From: Jayne Carter <jayne.carter@townsville.qld.gov.au>
Sent: Tuesday, 25 August 2026 4:11 PM
To: BNC Planning <enquire@bncplanning.com.au>; Sai Sontoso-Miller - BNC Planning <ssm@bncplanning.com.au>
Cc: Development Assessment <developmentassessment@townsville.qld.gov.au>; Shelly Sharma <shelly.sharma@townsville.qld.gov.au>
Subject: MCU26 0072 - Letter - Information Request - 719 Ross River Road Kirwan

BNC Ref. DA022-26
Council Ref. MCU26/0072
SARA Ref. 2608-54051 SRA

RE: APPLICANT RESPONSE TO INFORMATION REQUESTS – DEVELOPMENT APPLICATION FOR A MATERIAL CHANGE OF USE (OFFICE – EXTENSION TO OFFICE) AT 719 ROSS RIVER ROAD, KIRWAN QLD 4817

Figure 1-4 Extract of proposed development layout

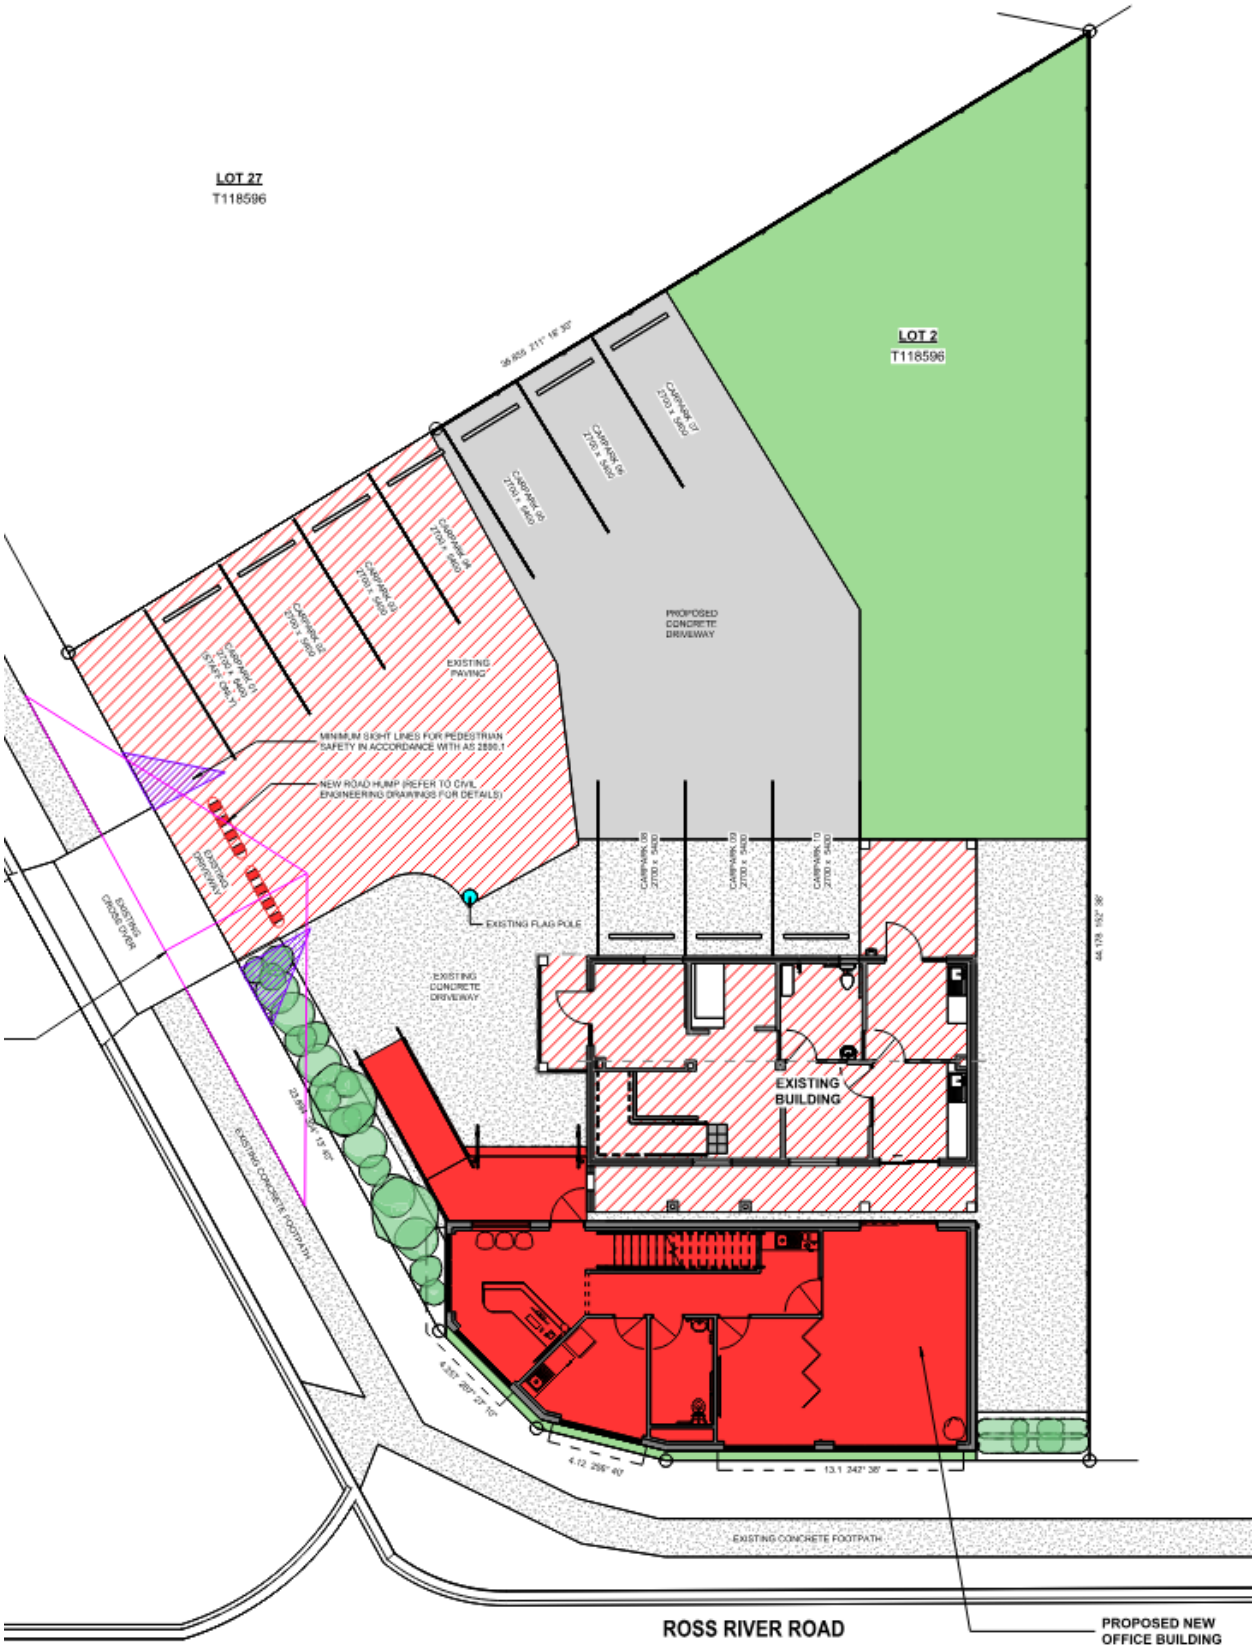
Response requested: Please provide an assessment of the stormwater and flood impacts, prepared and certified by a suitably qualified RPEQ, together with supporting civil drainage plans. The assessment must: identify existing and proposed catchments, flow paths, lawful points of discharge and drainage infrastructure; quantify pre-development and post-development peak flows and demonstrate no actionable worsening to the State-controlled road corridor or its drainage infrastructure; assess relevant flood events and demonstrate that the development does not worsen flood levels, velocities, duration, hazard or flood storage affecting the road corridor; demonstrate that stormwater quality, sediment, erosion and scour will be appropriately managed; identify finished surface levels and any changes to overland flow paths arising from the building, parking and associated works; and detail all mitigation, detention, treatment and scour protection measures required to protect the safety, structural integrity and operating performance of Ross River Road and Thuringowa Drive.

The existing impervious area of 519m^2 (57% of the site) will increase to approximately 865m^2 (94%) under the proposed development. Pre-development and post-development peak flows have been calculated using the Rational Method in accordance with the Queensland Urban Drainage Manual for events up to and including the 1% AEP. An effective detention storage volume of approximately 24m^3 is provided via an open drainage and detention system, with a controlled outlet discharging to the existing kerb and channel, sized so that post-development peak discharge does not exceed the corresponding pre-development peak flows for each design event, including the 1% AEP event. On this basis, the development will not result in an actionable worsening of peak flows to the state-controlled road corridor or its drainage infrastructure.
